BELMONT MIDDLE AND HIGH SCHOOL BUILDING COMMITTEE

SEPTEMBER 11 2019

UPDATED EXTERIOR VE ITEMS

ACOUSTIC WOOD PANELS COST REDUCTION STRATEGY

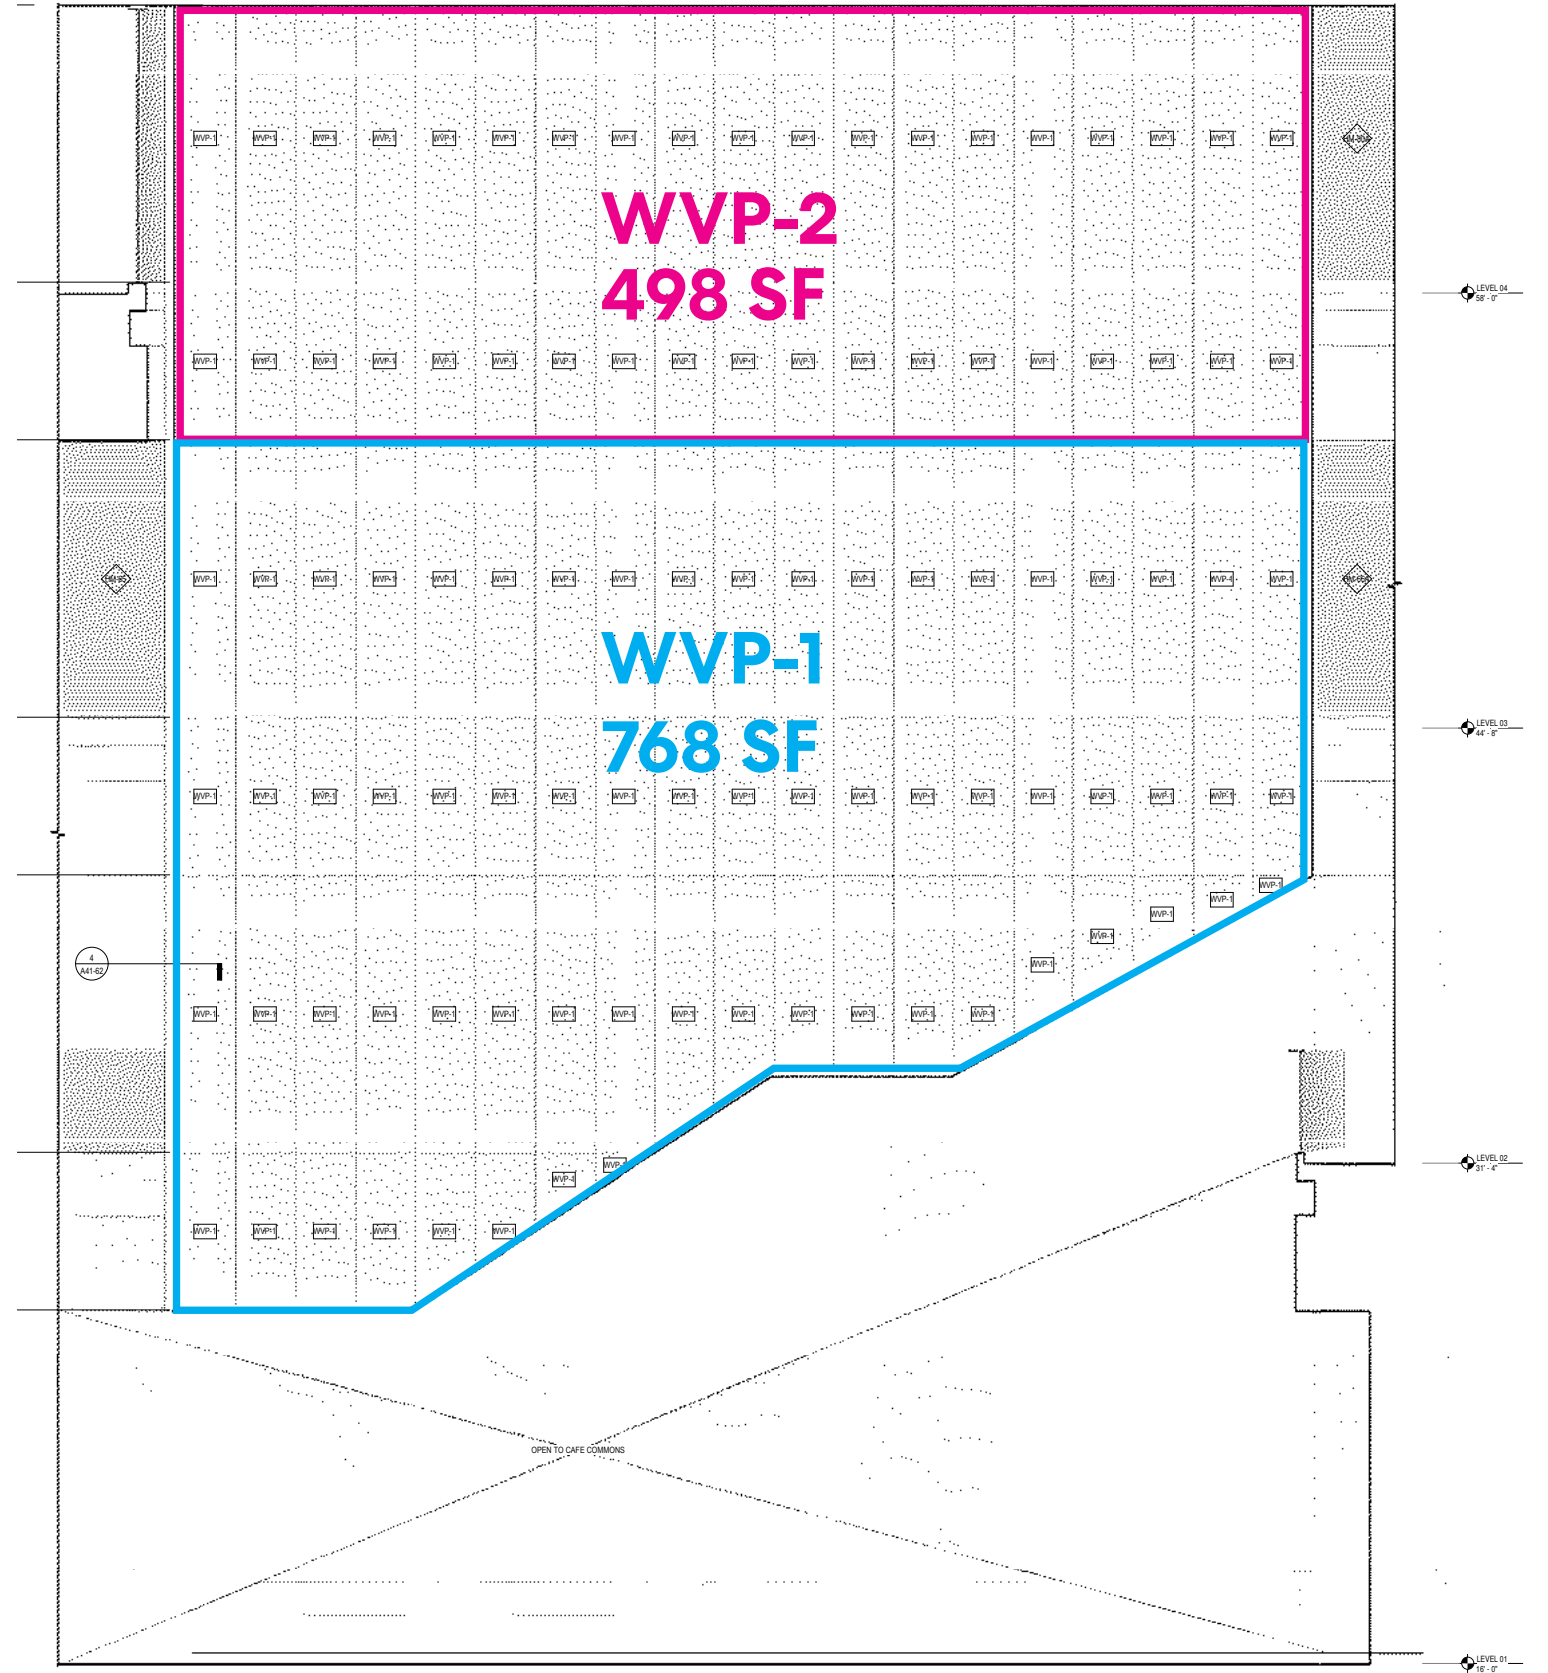
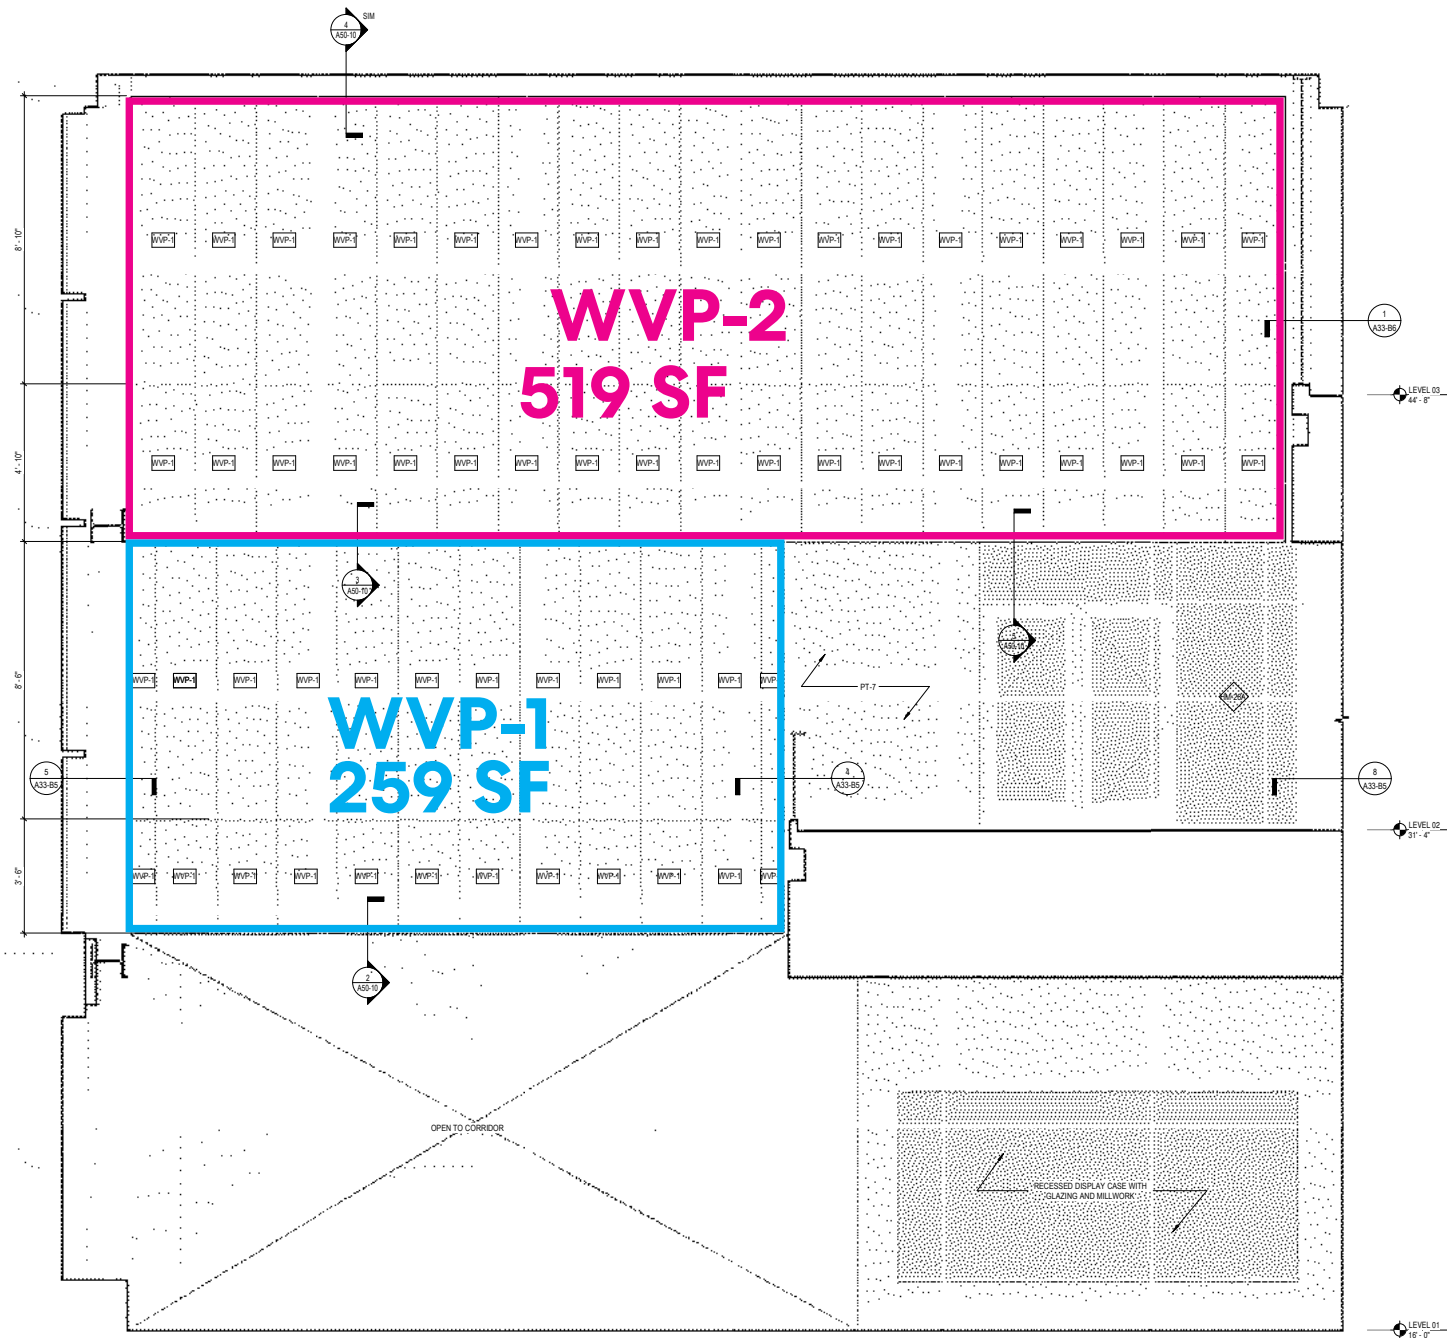
REDUCE WVP-1 PANELS

- WOOD PANELS
- WVP-1 ACOUSTIC WOOD PANELS
- WVP-2 NON-ACOUSTIC WOOD PANELS

GLASS RAILING REDUCTION STRATEGY

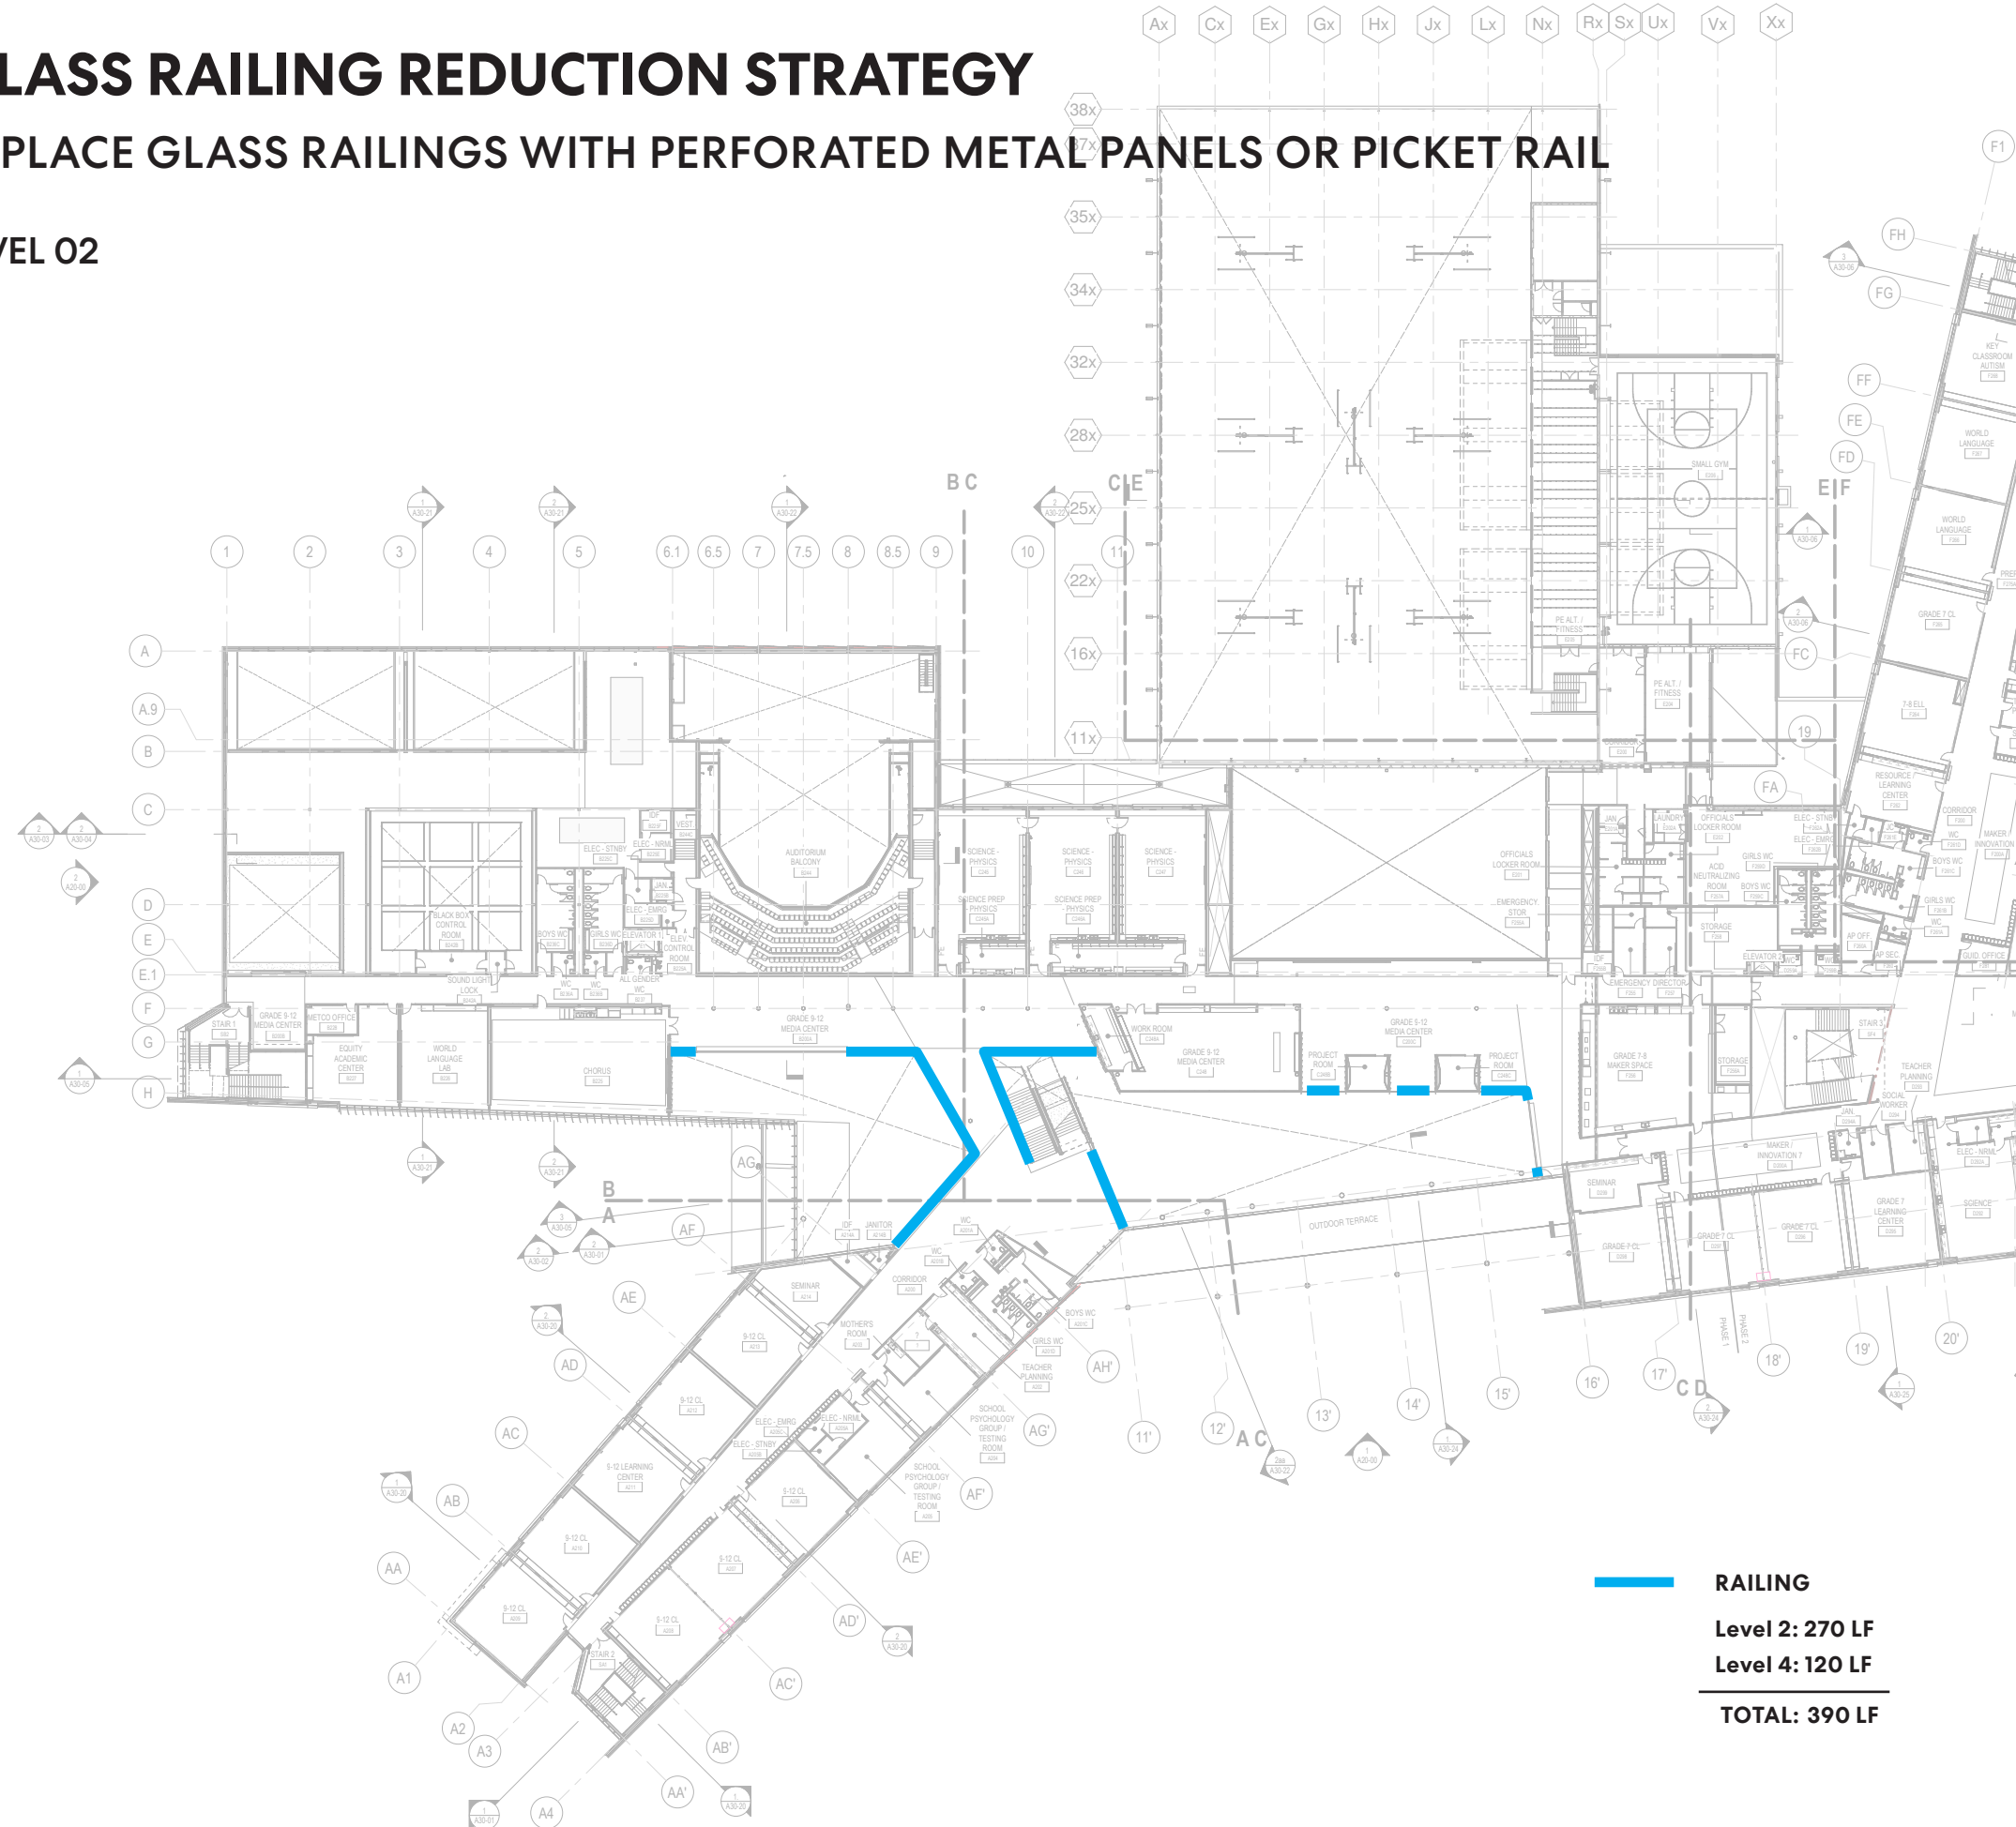
REPLACE GLASS RAILINGS WITH PERFORATED METAL PANELS OR PICKET RAIL
